# **AUBURN BOULEVARD OVER ARCADE CREEK BRIDGE REPLACEMENT PROJECT**

### **Response to Comments**

**AUBURN BOULEVARD BRIDGE OVER ARCADE CREEK  
BRIDGE REPLACEMENT PROJECT  
RESPONSE TO COMMENTS**

NORTHEAST SACRAMENTO COUNTY SANITATION DISTRICT  
 SANITARY TRUNK SEWERS DEL PASO PARK SYSTEM  
 PLAN AND PROFILE 011 LINE

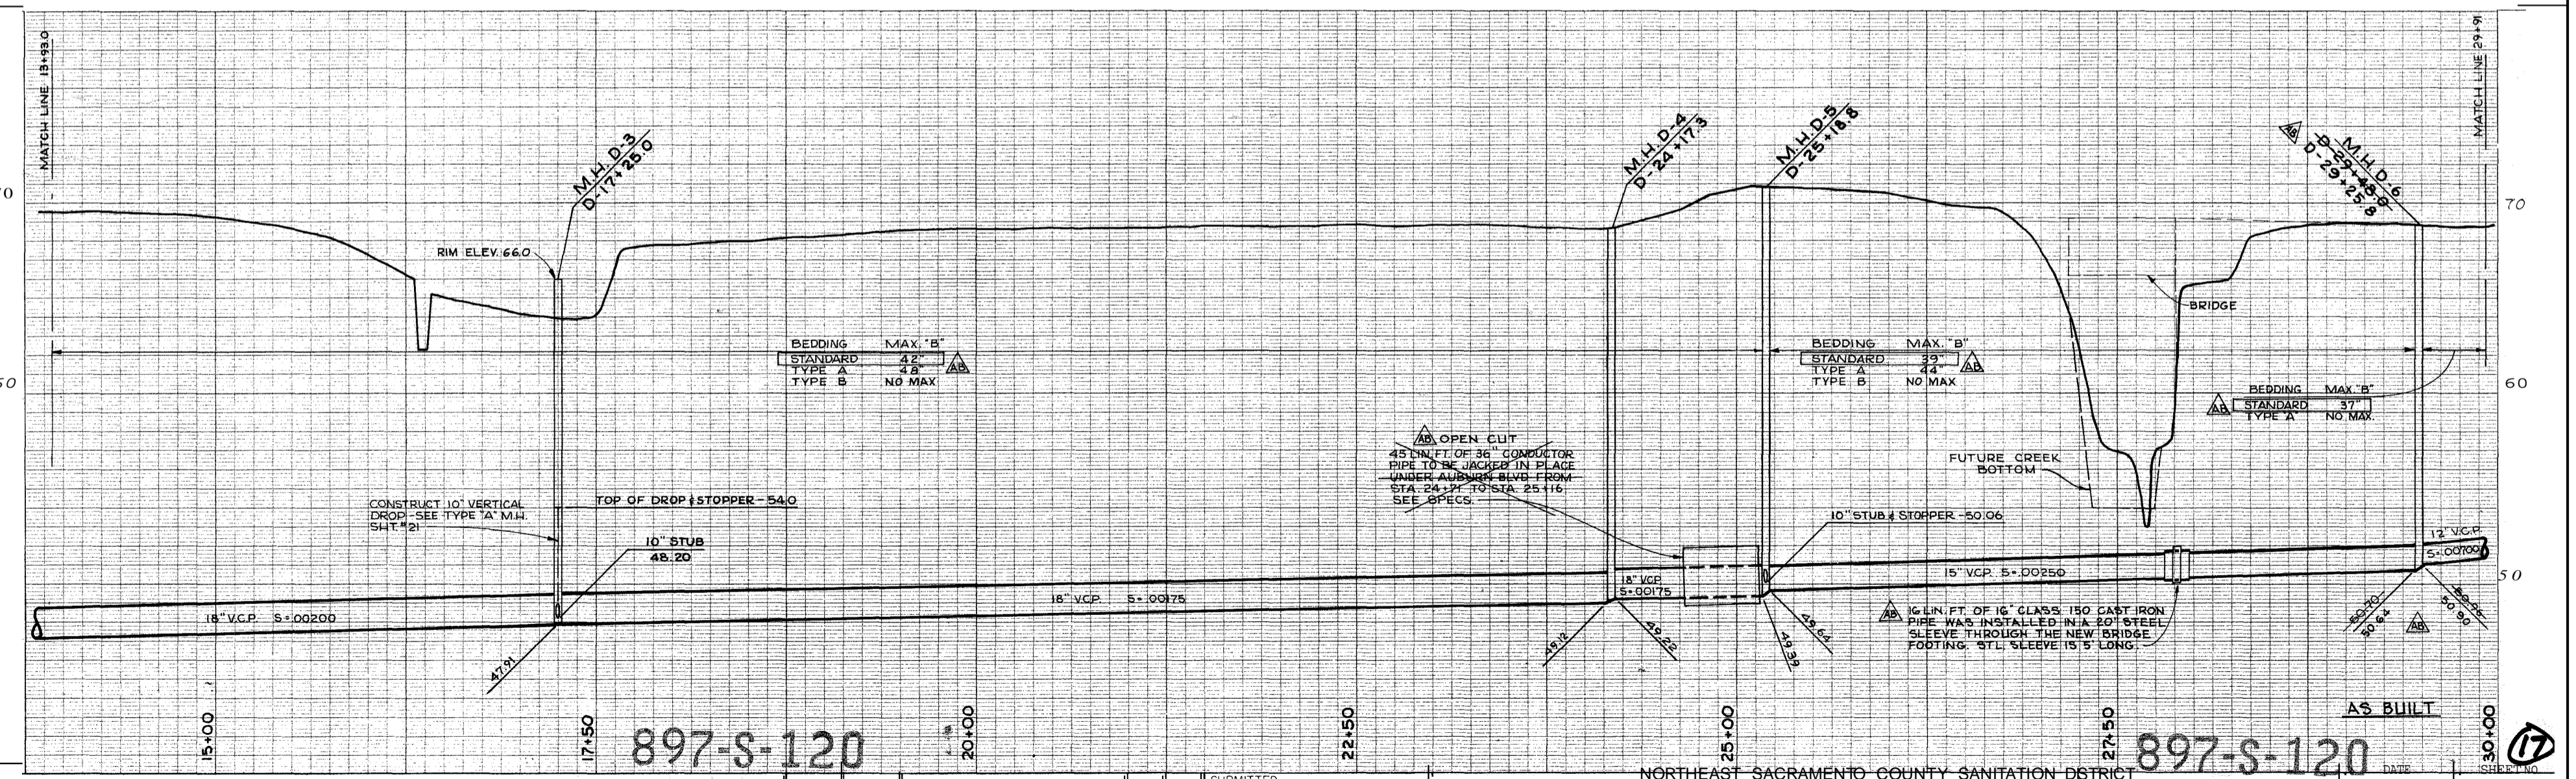
Regional San doesn't have any facilities located within the proposed project's boundaries; however, the Sacramento Area Sewer District (SASD) has a collector line located adjacent/within Auburn Boulevard. SASD will be responding to the NOA/MND informing of this facility.

**Acknowledge that Sacramento Area Sewer District (SASD) has a collector line located adjacent within Auburn Boulevard.**
